LOCAL HISTORIC DISTRICT: Wesley Heights

PROPERTY ADDRESS: 621 Woodruff Place

SUMMARY OF REQUEST: Landscaping plan

Charlotte Historic District Commission - Case 2016-216
HISTORIC DISTRICT: WESLEY HEIGHTS

Plan Type
Planting Plan

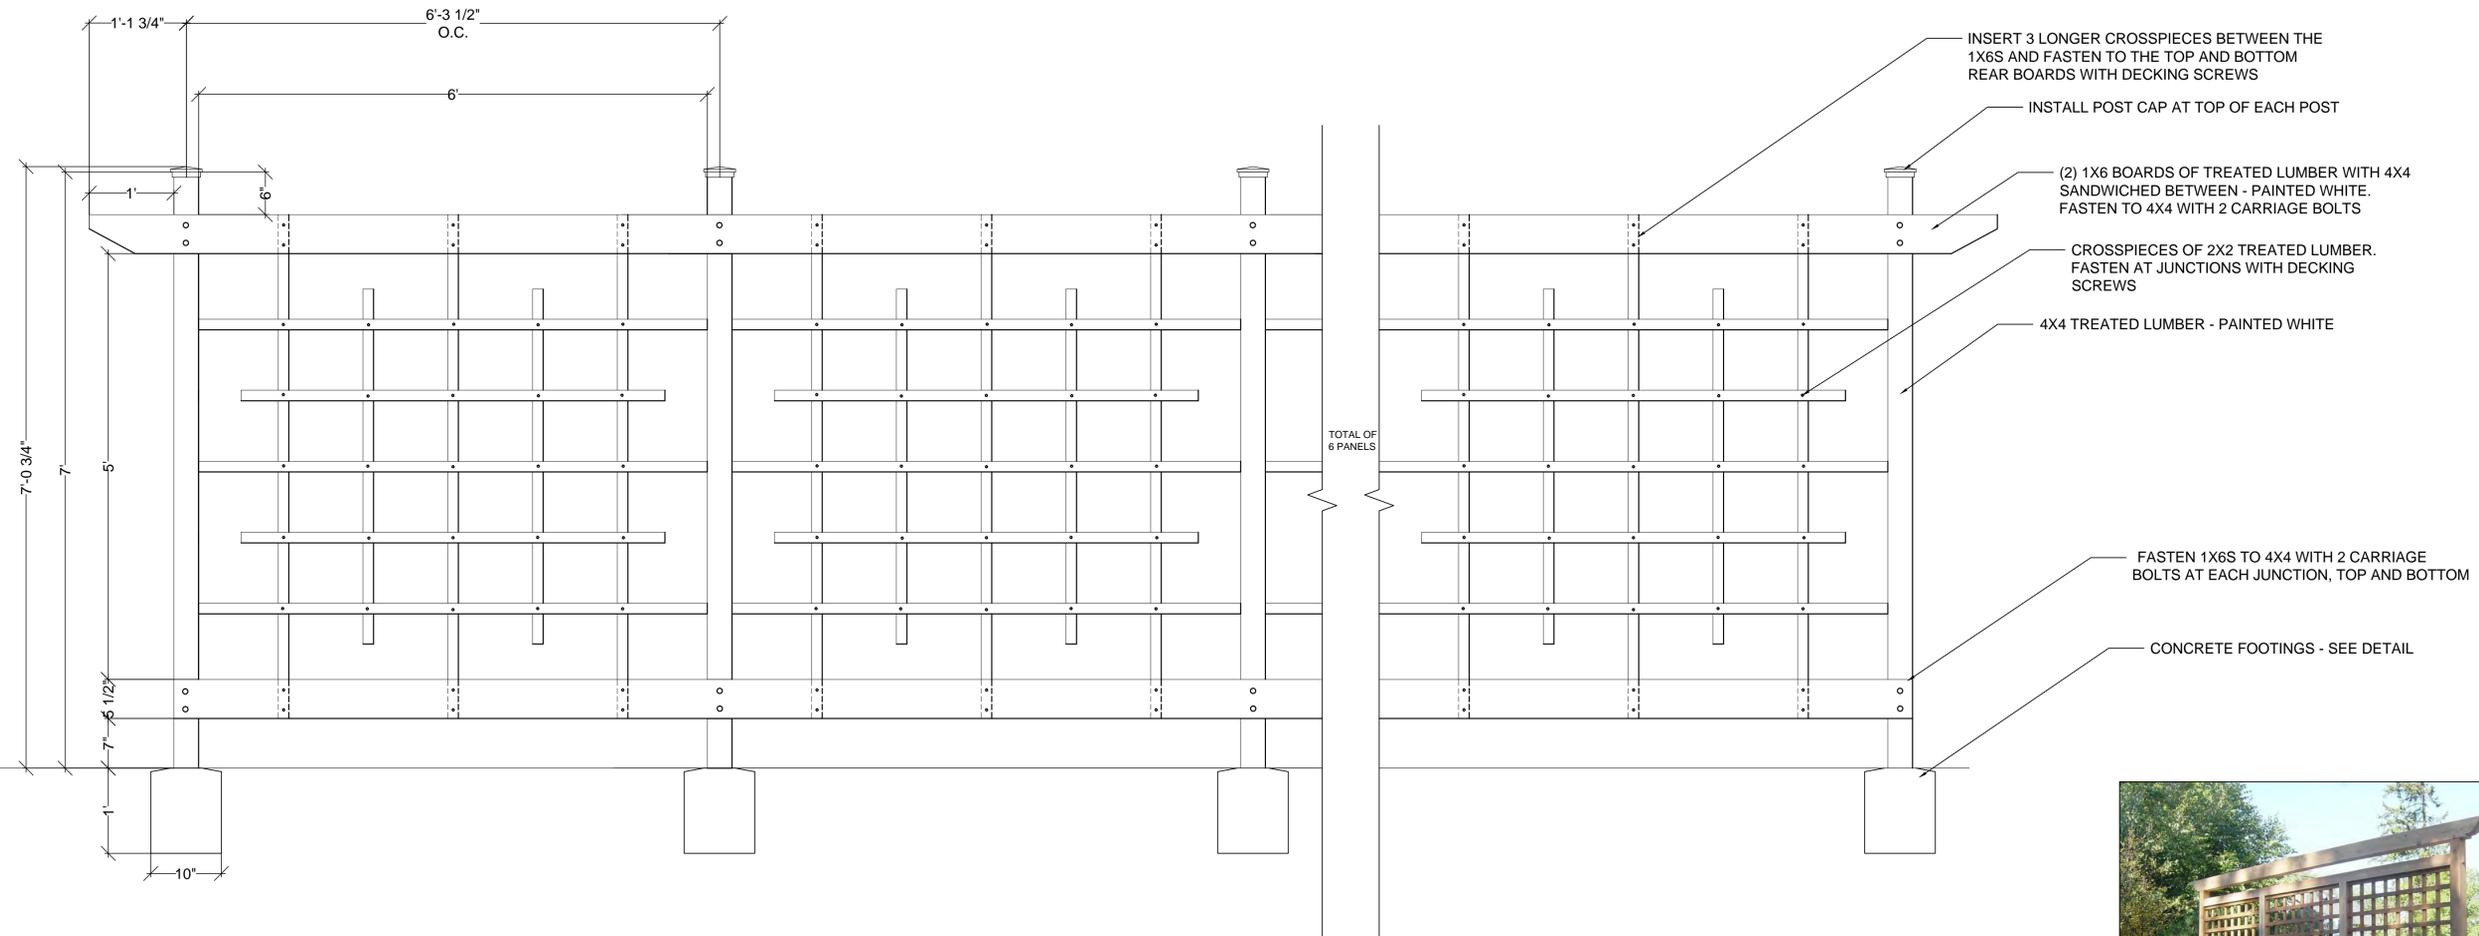
1. The landscape plan has been revised to show two trees replanted in close proximity of the original trees and the third located to the right rear corner.

The location of the trees in the backyard that have been outlined by MetroGreenscape on their blueprints are good. There should not be any effects from the existing root system from the old tree. If you have any further questions or concerns, please contact your Arborist, Chris Green.
